ADDENDUM NO. 2

**Farmington Correctional Center,
Replace Roofs & Tuckpoint Exterior Masonry,
Control Center & Treatment Center II
1430 Doubet Road
Farmington, MO 63640
PROJECT NO. C2504-01**

Bidders are hereby informed of the following:

OVERALL TUCKPOINTING ALTERNATE PHASING PLAN - TREATMENT CENTER 25

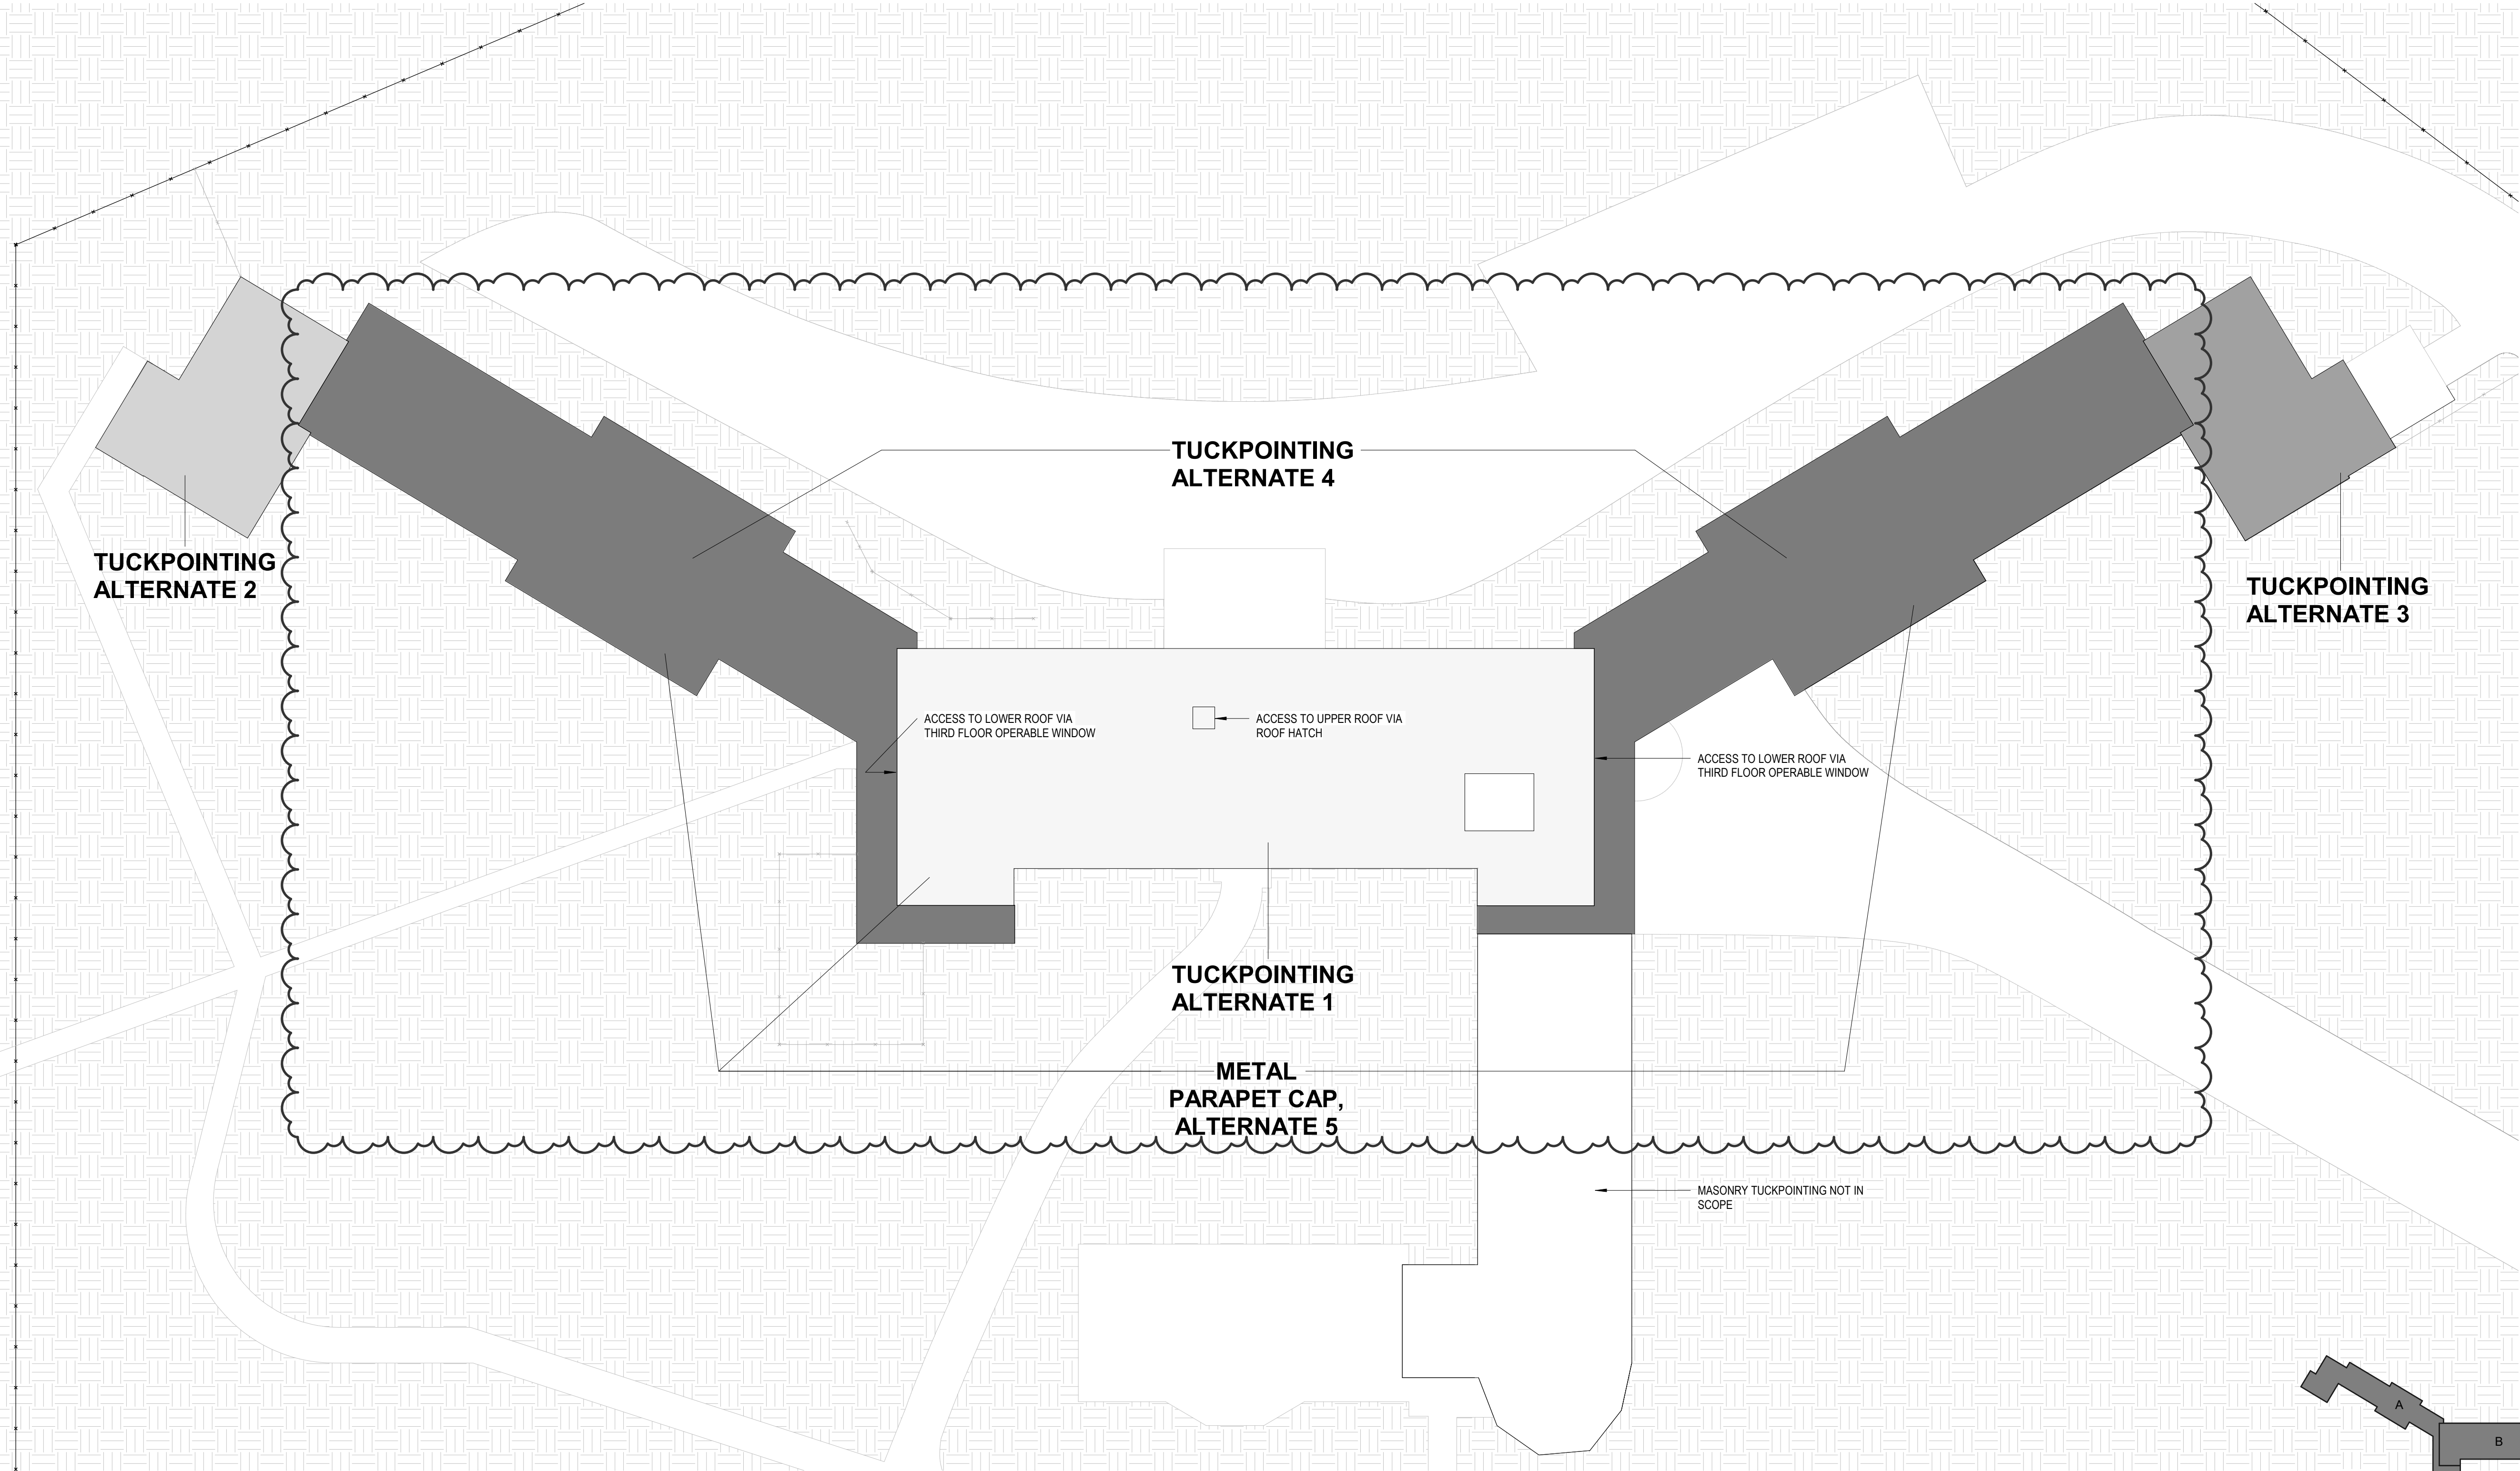
1. TUCKPOINTING ALTERNATE PHASING PLAN - TREATMENT CENTER 25, A004
 - a. Detail 1: Add Alternate #5 (metal coping cap) to roof plan.
2. MASONRY DETAILS, A206
 - a. Detail 9: Removed notes regarding unit pricing.

9 TYPICAL CRACKED BRICK REPLACEMENT

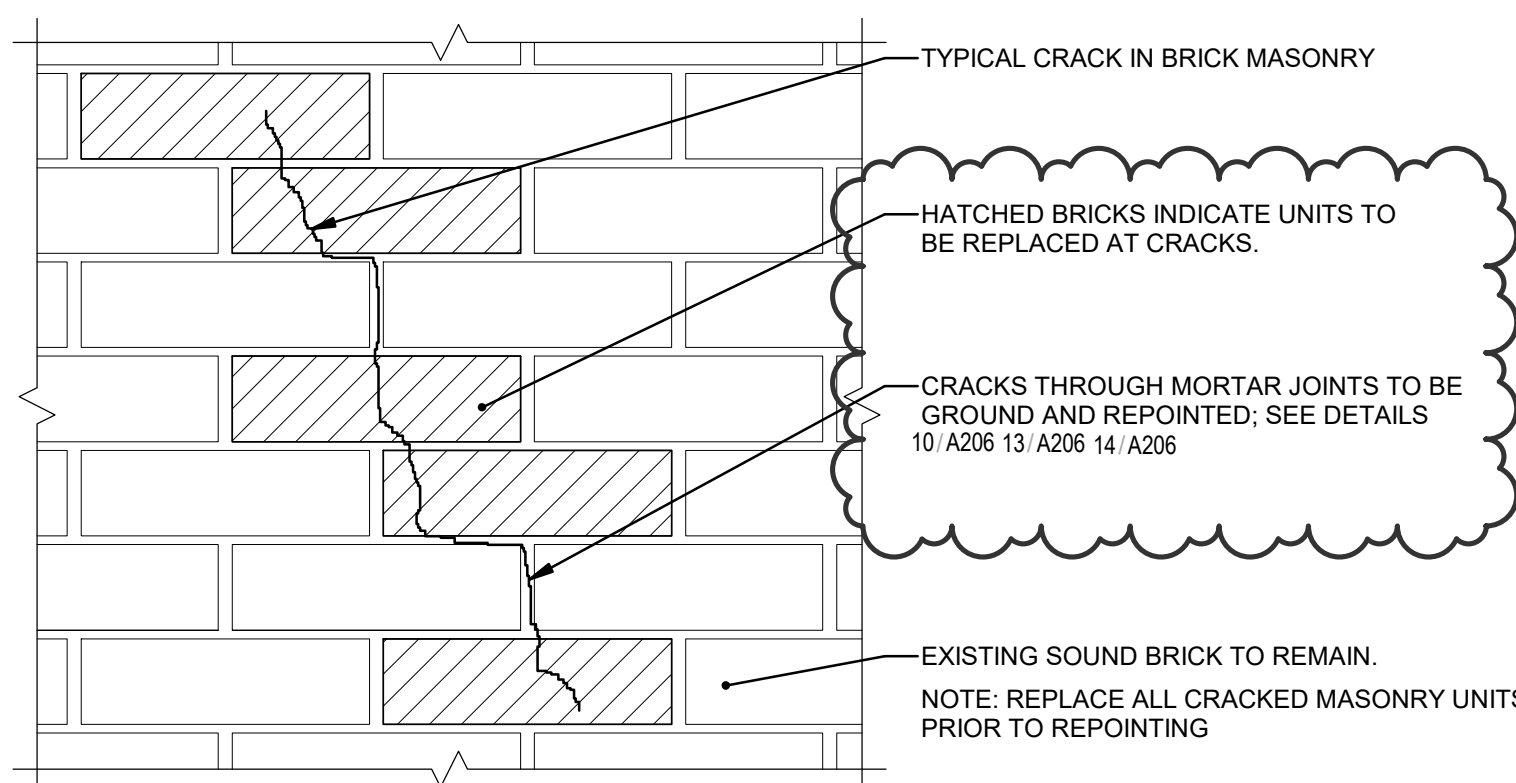
However, for areas where wall is 1" of out plane, existing brick shall be removed and reinstalled. Contractor to field verify any areas requiring brick replacement.
8. Can a quantity be given for the number of damaged bricks to be replaced. Plan sheet A206, note 9, says bricks to be replaced and deducted from unit price allowance. I did not see a unit price in specifications for brick replacement.
Answer: Contractor to field verify all masonry locations requiring work. Detail 9/A206 has been updated to remove note about unit price. See answer #7.
9. During the site visit it was noted that there were several areas of damaged capstones, do these areas need to be repaired?
Answer: Where capstone is cracked or where delamination occurs, the parapet cap stone shall be replaced. See Detail 8/A501.

9 SECTION DETAIL - PARAPET, TYPICAL AT BUILDING 25

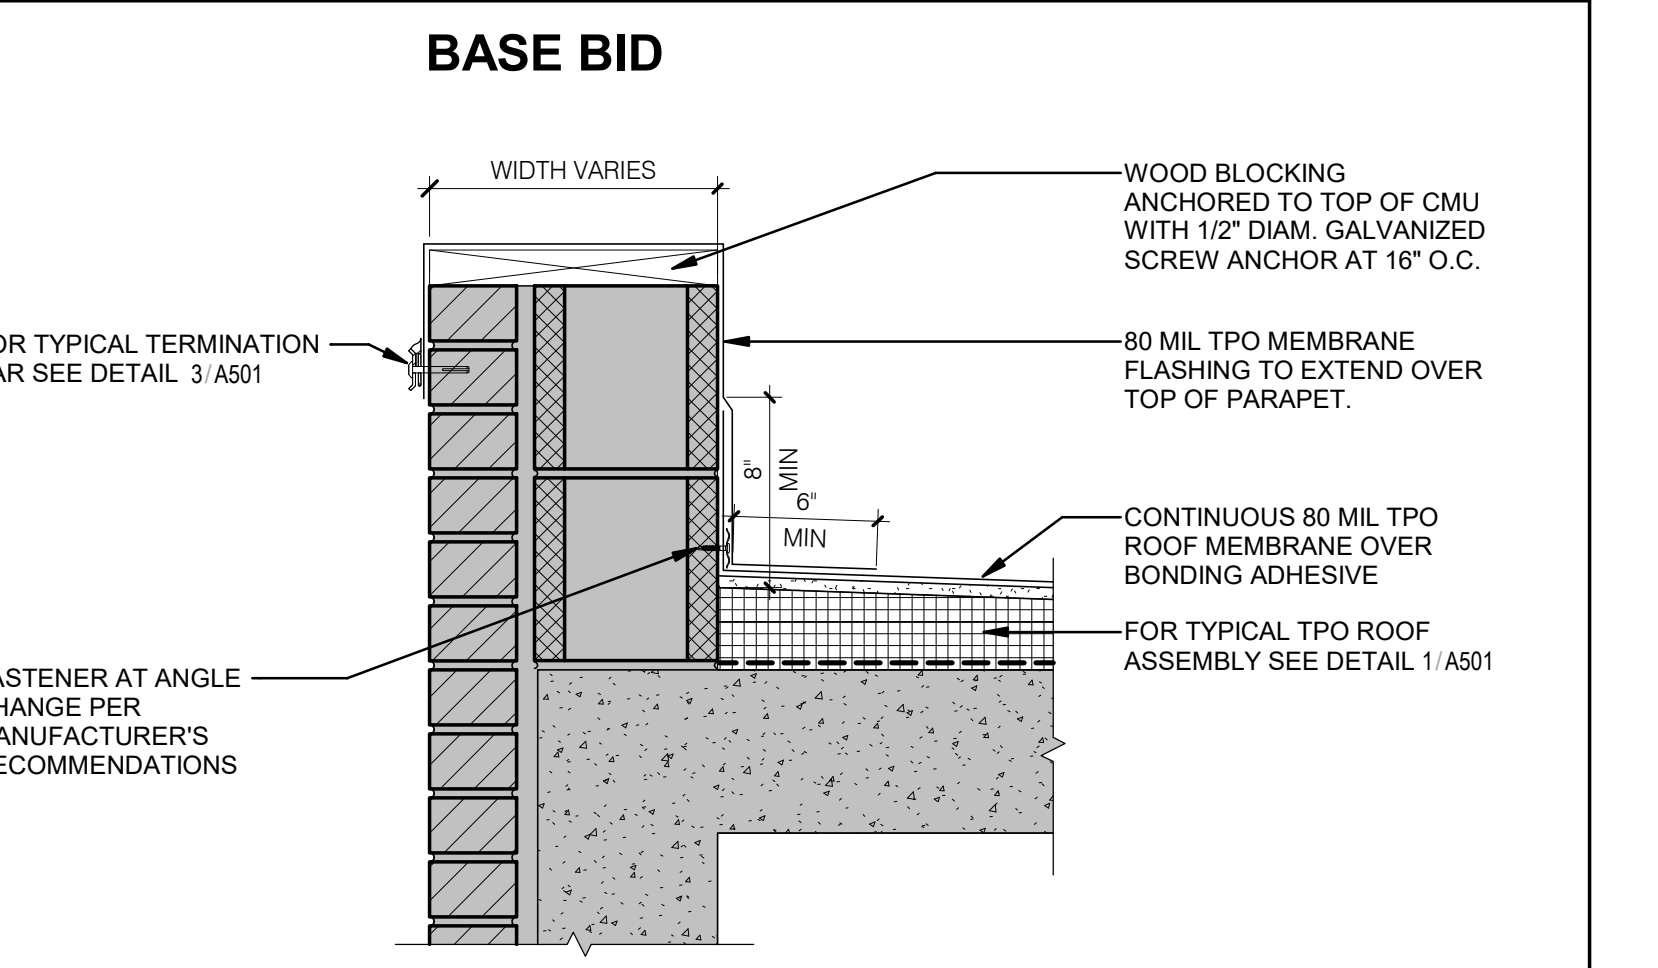
- a. Detail 8: Revised cap stone note to include replacement requirements.
- b. Detail 9: Defined metal cap detail to Alternate #5.

15. Bldg. #25 does the Base bid cover the TPO wrapping over the top with no Cap?
Answer: Yes. At building #25, the base bid shall be wrapping the parapet with a TPO membrane and finish with a termination bar as noted in 9/A501.

See alternate #5 metal coping cap detail in 9/A501.
16. Please clarify Base Bid Amount, Documents show 6,2341 sq. ft.
Answer: Quantity is 6,234 SF
17. There is no Base Bid qty. this work seems like it would be an Alt. or part of Base Bid. The Facility was under the impression the TPO would just wrap over the top with no cap.
Answer: Base bid is TPO over parapet.
18. Base Bid 10%, 103 In ft. Which is it?
Answer: Quantity is 103 LF
